**Medway Planning & Economic Development Board
Meeting**

**Rocky's Hardware – Outdoor Display
Special Permit and Administrative Site
Plan – 98 Main Street**

ROCKY'S ACE HARDWARE
GARDEN CENTER PLAN
98, 108 & 114 MAIN STREET
MEDWAY, MA.
FOR
MEDWAY REALTY, LLC
DATE: JULY 12, 2021

**Re: Rocky's Ace Hardware
Administrative Site Plan Review
98 Main Street
Medway, Massachusetts**

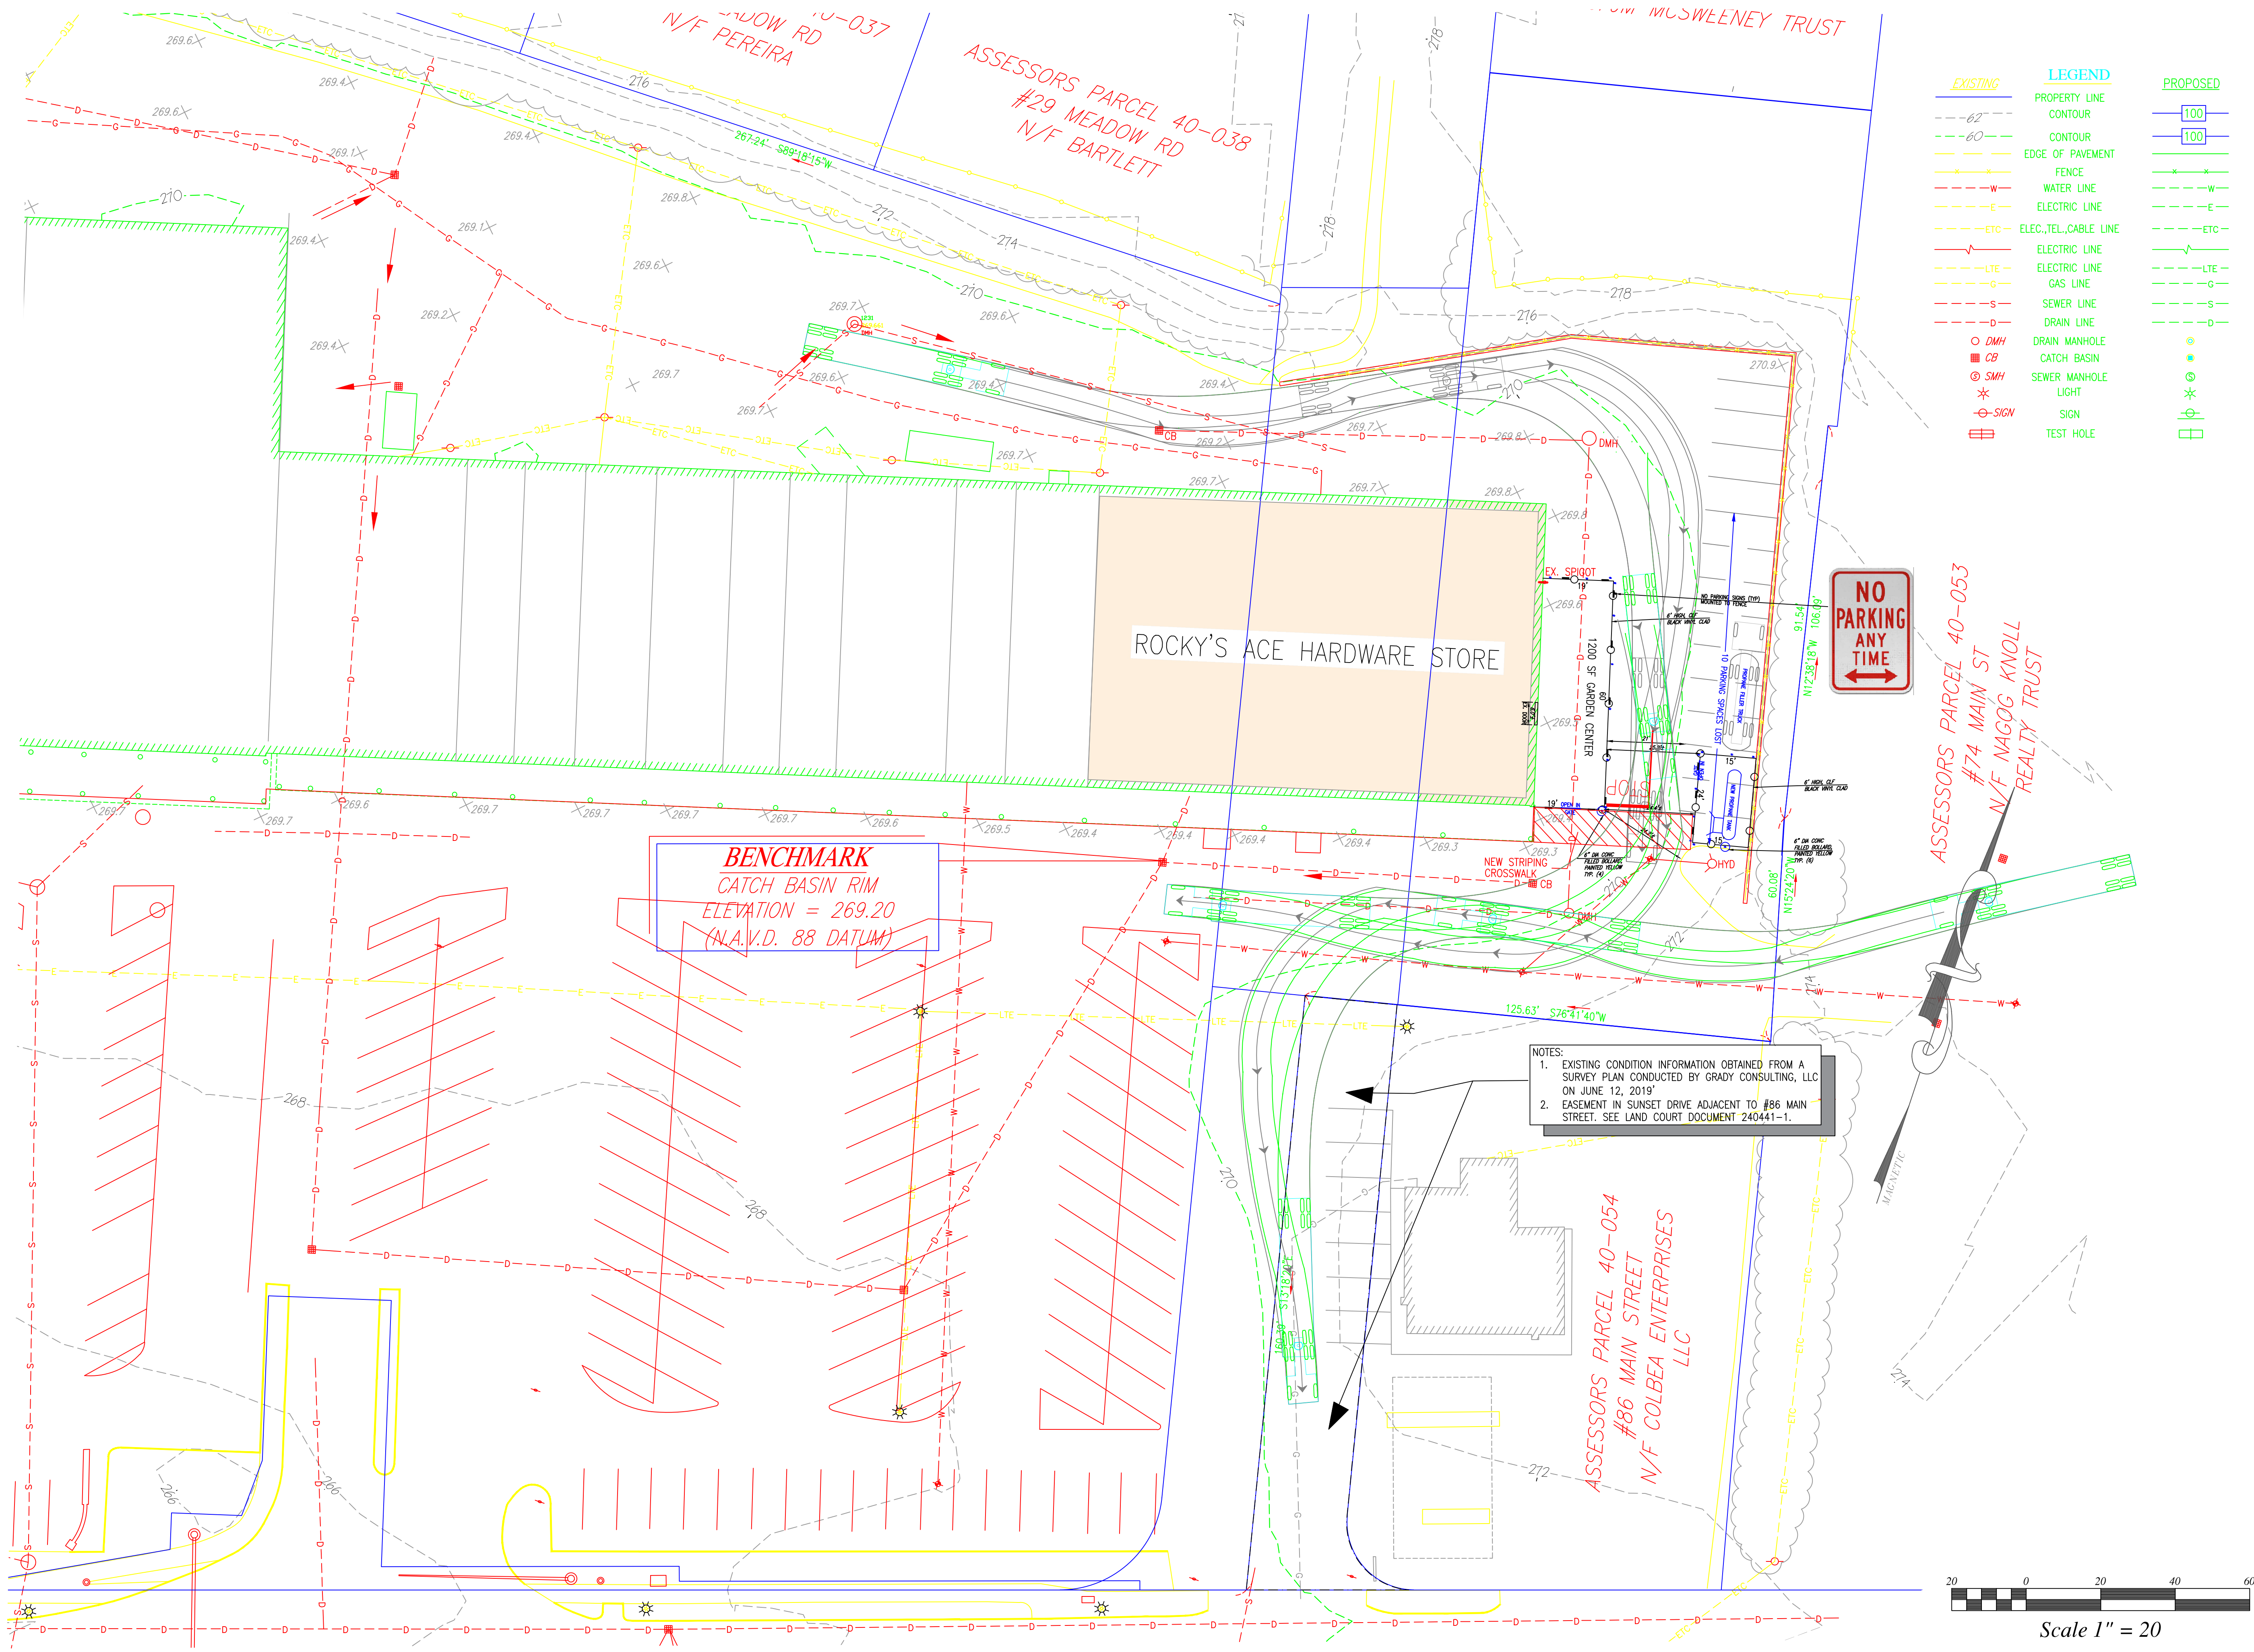
1. *The actual dimensions of the outdoor display area are not shown on the provided site plan. It is important to know the length of each side of the fence, rather than just the description of "up to 1200 square feet" as noted in the special permit application, or "approximate 1200 SF" as shown on the plan. The plan should be revised to include the dimensions.*

2. *The written description indicates that the outdoor display area will surrounded by protective bollards. The site plan does not show the bollard locations for the outdoor display area. The plan should be revised to specify the locations of the protective bollards.*

3. *Will there be access to the outdoor display area directly from any point outside, or will the area be accessible only through the store? Any gate proposed for the fencing should be shown.*

4. *How many parking spaces will be lost by the addition of the outdoor display area and the propane fill station? Is that loss of spaces reflected in the Parking Spaces Summary table on Sheet C1.00?*

5. *The plan does not specify what type of fencing is proposed around the outdoor display area and the propane fill station area. The text in the project description indicates it will be black vinyl chain link fencing. What height of fence is proposed? The plan should be revised to indicate that information and include a fencing detail.*

1. *There needs to be always an unobstructed laneway of 20' wide between the propane filling station and the outdoor display enclosures. It appears that such is provided.*

2. *How are propane deliveries handled? A clearly designated area should be specified on the plan for where propane delivery trucks will park. Signage should be provided on the fence to direct delivery trucks to park in the specified location. Propane delivery parking cannot obstruct access around the building and the outdoor display area by emergency vehicles.*

3. *Signage should be included on the fences to state no customer parking in front of the outdoor display enclosure and propane filling station. Customer parking cannot obstruct access around the building and outdoor display area by emergency vehicles.*

1. *Show more bollards around the outdoor display and propane fill station fences.*

6. *Add striping to visually extend the sidewalk to the propane area in order to protect pedestrians. Consider adding bollards along the southerly side of the striping.*

9. *Show the turn angles and paths for large trucks between the garden center and propane fill station and to the west to demonstrate that delivery vehicles can turn within the property boundaries.*

1. We do not anticipate any issues with stormwater as the proposed garden center area is located on existing asphalt. However, the plan should include the as-built stormwater infrastructure that was recently installed under the proposed display area to ensure fence posts and bollards do not impact the infrastructure below. (Ch. 200 §206-3.B.4)
 - *PAL Response: The as-built stormwater infrastructure is shown on the plan.*
 - **TT 2/5/21 Update: In our opinion, this item is Resolved.**

- **TT 2/5/21 Update: The Plan accurately depicts the proposed work and we would not oppose a waiver request from this regulation.**
4. The driveway width between the proposed garden center fence and existing parking is proposed at 20 feet which does not comply with the required 24-foot width in the Regulations. Entering and exiting the existing 90° parking spaces may be difficult adjacent to the garden center. (Ch. 200 §207-11.B.3)

- *PAL Response: The plan now shows a 24' wide travelled way. Changing the width causes a loss of 10 parking spaces.*
 - **TT 2/5/21 Update: We recommend the Applicant consider decreasing the width (and increasing the length if similar square footage is needed) of the garden center to maintain the 24-foot drive aisle rather than losing 10 parking spaces.**

- **TT 2/5/21 Update: We recommend the PEDB acquire written correspondence from the Fire Department related to this Comment.**
10. Additional bollards may be necessary to protect the proposed propane tank. No bollards are proposed along the western side of the tank enclosure and a car may be able to fit between the proposed bollards on the northern and southern sides of the enclosure. A bollard detail should be provided on the Plans.

- **TT 2/5/21 Update: The bollards shown in the photo are not consistent with what is shown on the plans (ie. photo appears to show a bollard every three to four feet, the plans show greater distance between bollards). The Applicant shall provide actual locations of the bollards on the Plan.**

RESPONSE: The plan has been changed to show the length of each side of the outdoor display area.

RESPONSE: The plan has been changed to specify the locations of the protective bollards.

RESPONSE: The plan has been changed to show the location of the gate. The gate on the outdoor display area faces toward Main Street and opens inward.

RESPONSE: There will be a loss of 10 parking spaces as shown on the plan due to the width of the travelled way being increased to 24 feet. There was some discussion by the Board about preserving these parking spaces, but this would require a 3' reduction in the width of the travelled way. Rocky's will work with Medway Realty, LLC ("Medway Realty") regarding any changes to the site plan after this question has been finalized.

RESPONSE: The plan is revised to show a 6-foot black vinyl coated chain link fence around the propane filling station and a 6-foot black vinyl coated chain link fence around the outdoor display area.

RESPONSE: Rocky's has provided a 24' wide travel lane between the propane filling station and outdoor display enclosure. If the Board would prefer to preserve the parking spaces near the propane filling station, then that travel lane will need to be reduced to 21'.

RESPONSE: The area where the delivery truck will be parked during propane deliveries is marked on the plan. Safety signage directing deliveries to this area will be placed on the fence. The propane delivery truck will not obstruct access around the building. If the Board would prefer to preserve the parking spaces, then Rocky's is committed to marking off the area where the propane delivery will occur with cones or other markers to assure that the propane delivery truck can park on those parking spots adjacent to the propane fill station.

RESPONSE: As shown on the plan, safety signage stating that no parking is allowed will be prominently placed on both the outdoor display fence and the propane fill station fence. Rocky's will work with Medway Realty to assure that no parking is tolerated in these areas to prevent obstruction of emergency vehicles.

RESPONSE: The plan now shows a 24' wide travelled way. Changing the width causes a loss of 10 parking spaces.

RESPONSE: Striping is shown on the plan running from the end of the sidewalk in front of the store, across the front of the outdoor display area, and across the vehicle lane to the propane fill station. The addition of bollards along the southerly side of the striping will likely interfere with the turning radius needed to stay on Medway Place property.

RESPONSE: The turn angles between the outdoor display area and propane fill station to the west are shown on the plan to demonstrate trucks can turn within the property boundaries.
